SERVICE BULLETIN

SB # 160330-5905587WE

SUBJECT: Excess epoxy on the inside surfaces of the Fuel Filter Element that may become detached and flow into the downstream fuel system.

Figure 1, Excess Epoxy on Inner Surface of Fuel Filter

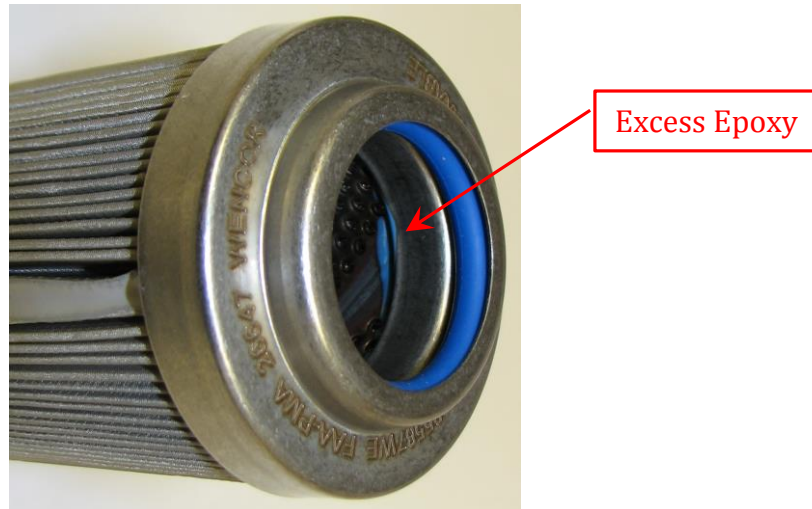
During the manufacturing of the Fuel Filter Element, epoxy is used to attach the filter components to the filter end caps. Some Filters were manufactured with excess epoxy on the inner surfaces of the Filter as shown in Figure 1. The excess epoxy may become detached and potentially contaminate the downstream fuel system components and may ultimately lead to engine malfunction.

Figure 2, Filter Section View Showing Area for Visual Inspection for Blue Epoxy

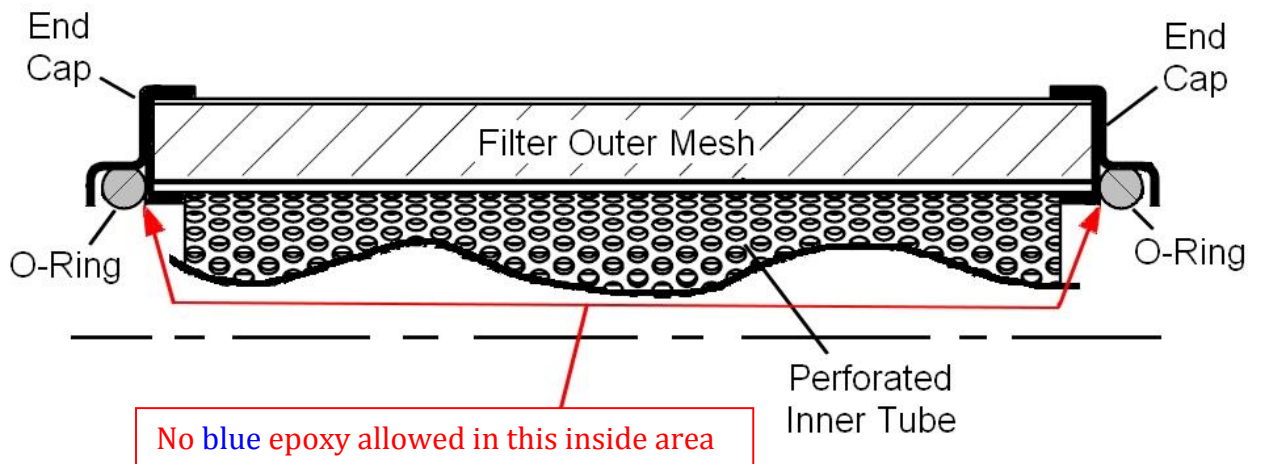
Within the compliance time given below in section 6, any Wencor Fuel Filter Element, PN 5905587WE, that was purchased from Wencor before March 2016, that is currently installed into the NHA Power Driven Rotary Fuel Pump shall be removed and be visually inspected for excess epoxy on the inner surfaces. Any blue colored epoxy located on any of the Filter inner surfaces as shown in Figure 2 is cause for removal and replacement of the Fuel Filter Element per section 7 below.

All Wencor Fuel Filter Element's that were purchased from Wencor before March 2016 and are not installed into the NHA Power Driven Rotary Fuel Pump or are installed into spare Pumps that are not yet in service shall be visually inspected for excess epoxy located on the inner surfaces as shown in Figure 2. If excess epoxy is found, the Filter shall be returned to Wencor for replacement per section 7 below.

Fuel Filter Elements that are found to be free of excess epoxy shall be permanently marked on the end cap with “**OK**” using a manual scribe or hand held vibro-engraver (reference SAE AS478-2D or -5A) and may be reinstalled for continued service if all other instructions for continued airworthiness have been verified.

Fuel Filter Elements that are found to be free of excess epoxy shall be permanently marked on the end cap with "OK" using a manual scribe or hand held vibro-engraver (reference SAE AS478-2D or -5A) and may be put into service.
